DESIGN DS ₇	DRAWN BY		DART AEROSPACE LTD VICTORIA INTERNATIONAL AIRPORT, CANADA				
CHECKED	APPROVED	DRAWING	NO.				REV. A
7	4	DEO	9077		SHE	ET (OF
DATE		TITLE					SCALE
97.08.21		206	SKIDTUBE	HOLE	SPACING	CHA	NGES

DART ENGINEERING ORDER

TO AMEND DWG: DZ650 REV. B

D2654 REV. B

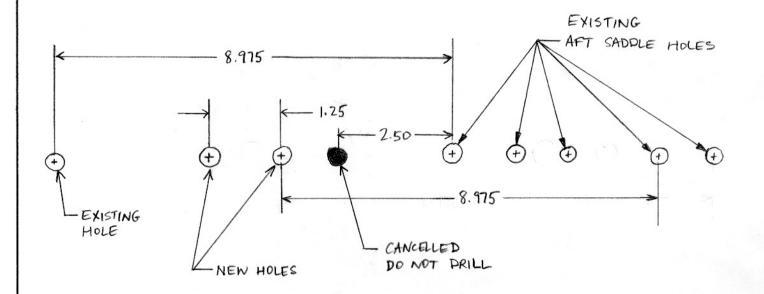
THE HOLE PATTERN NEAR THE APT SAPPLE HOLES OF THE 206B TUBES (D2650-1 AND D2650-3) AND WEBS (D2654-1 AND D2654-3) SHOULD BE MODIFIED AS FOLLOWS:

D2650-1 WILL NOW REQUIRE 19 D2649 CROSS BOLT SPACERS D2650-3 WILL NOW REQUIRE 20 D2649 CROSS BOLT SPACERS
